# 1984 - 1985 Corvette: Service Bulletin: Improperly Installed Reverse Idler Shaft Roll Pin

**Subject:** IMPROPERLY INSTALLED REVERSE IDLER SHAFT ROLL PIN

**Model and Year:** 1984-1985 CORVETTE

**Bulletin Number:** 85-31 - (01/09/1985)

FIG. 1 REVER

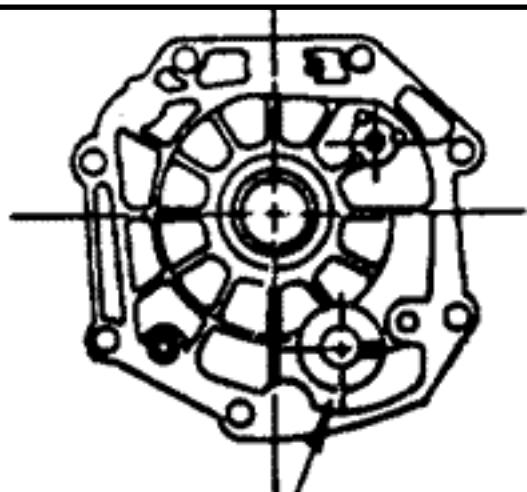
Damage to the manual transmission may occur if the roll pin securing the reverse gear idler shaft to adapter plate (Figure 1) is not fully seated to prevent the shaft from spinning and/or backing out. To insure assembly operation results in the shaft securely locked in place, the roll pin has been lengthened from 0.50" to 0.75". When servicing transmissions with the shorter roll pin (0.50"), discard the roll pin and replace with longer roll pin (0.75") maximum.

FIG. 2 PIN INSTALLATION

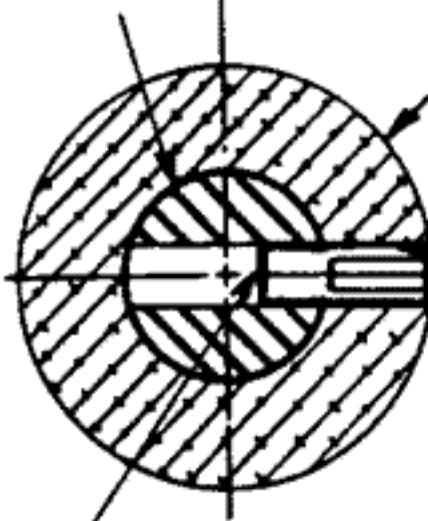
2. Insert 0.75" roll pin into plate boss hole and, with small punch tool, carefully drive roll pin flush with plate boss (Figure 2).

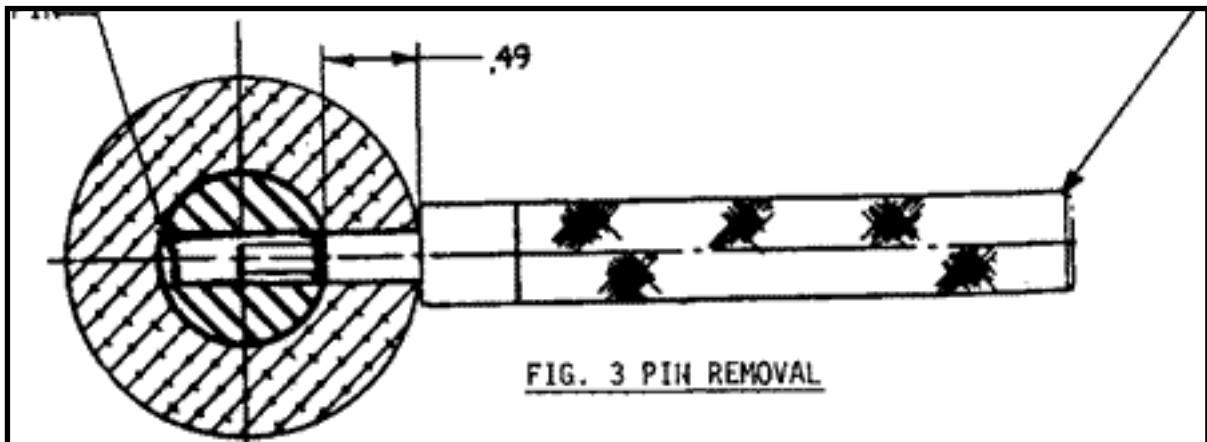
1. Insert small punch tool into plate boss hole and carefully drive roll pin into reverse idler shaft (Figure 3).
